U.S. NUCLEAR REGULATORY COMMISSION REGION I  
OPERATOR LICENSING EXAMINATION REPORT

EXAMINATION REPORT NO. 50-317/92-11 and 50-318/92-11 (OL)  
FACILITY DOCKET NO. 50-317 and 50-318  
FACILITY LICENSE NO. DPR-53 and DPR-69  
LICENSEE: Baltimore Gas and Electric Company  
Post Office Box 1475  
Baltimore, Maryland 21203  
FACILITY: Calvert Cliffs Nuclear Power Plant, Units 1 and 2  
EXAMINATION DATES: April 27 through May 1, 1992

**3.0    POST-TEST LICENSEE COMMENTS AND NRC RESPONSE**

# MAKEUP WATER REQUIRED FOR RCS COOLDOWN

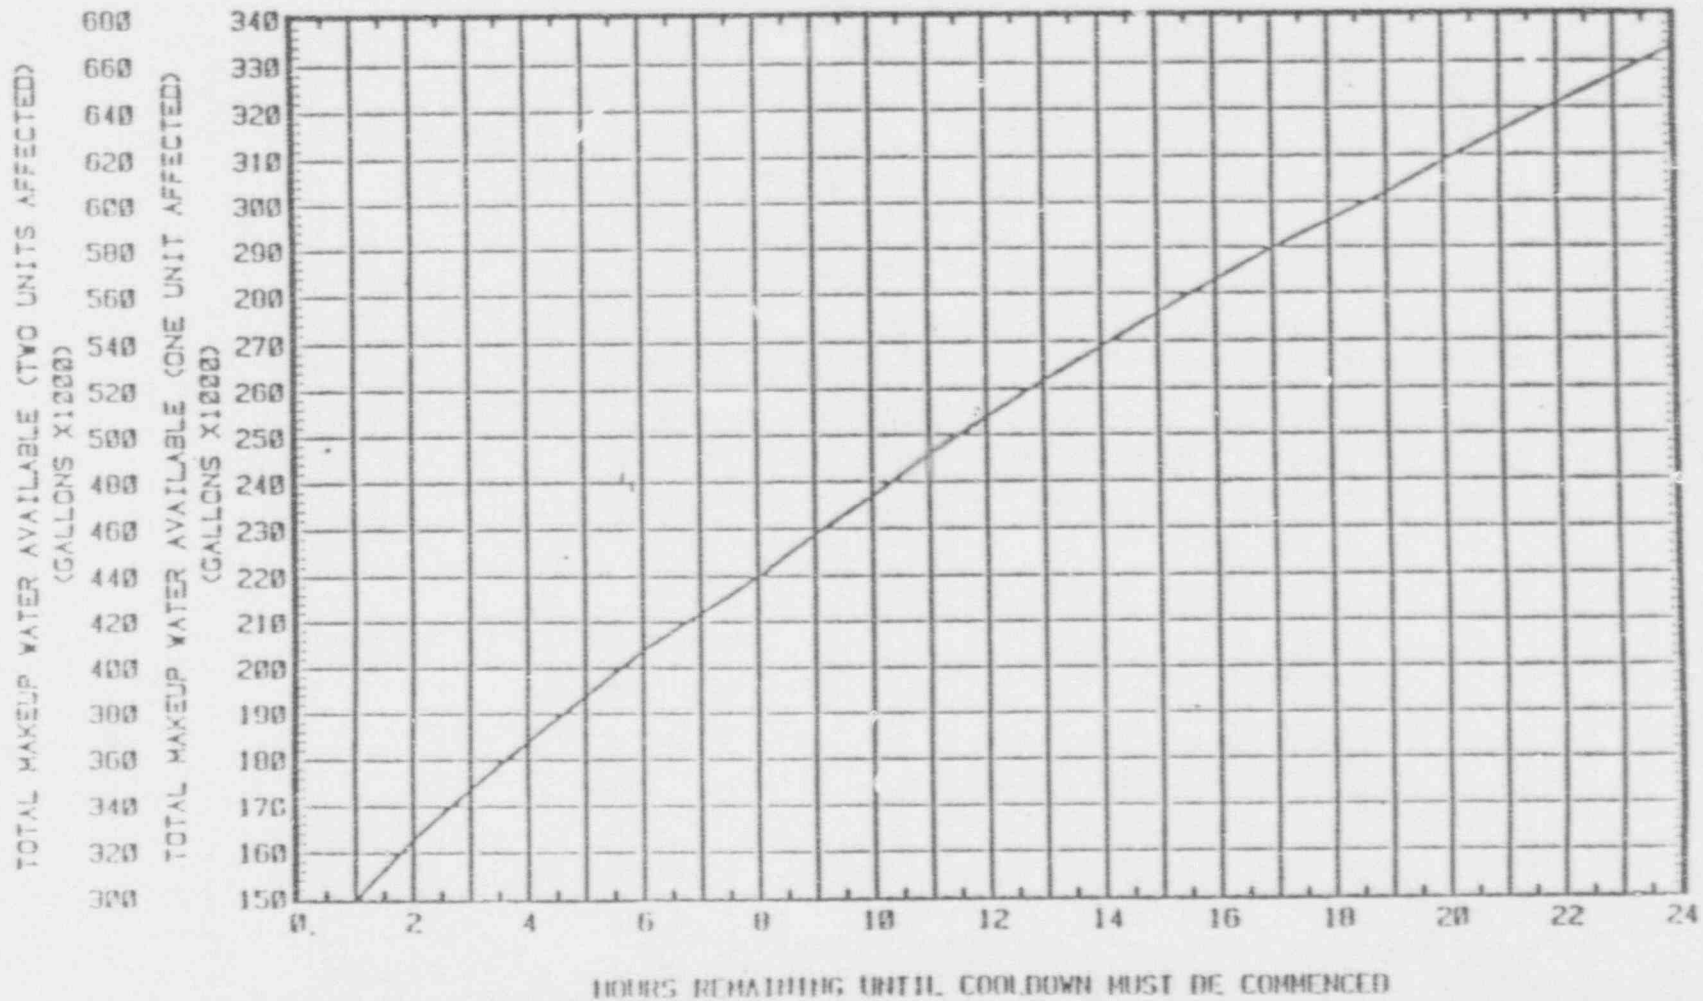
The facility states that current procedures do not provide guidance for using EOP Attachment 11 in the manner required by the question. The question required the examinee to determine the time required for both units to commence a cooldown. EOP Attachment 11 has 2 scales for CST water inventory (single unit affected and both units affected), however, one of the curves is no longer used (both units affected). This question requires the examinee to make assumptions that may not be valid. Based on the examinees assumptions, answers a., b., or c. could be correct.

Concur with the facility's comment. The question was deleted from the examination.
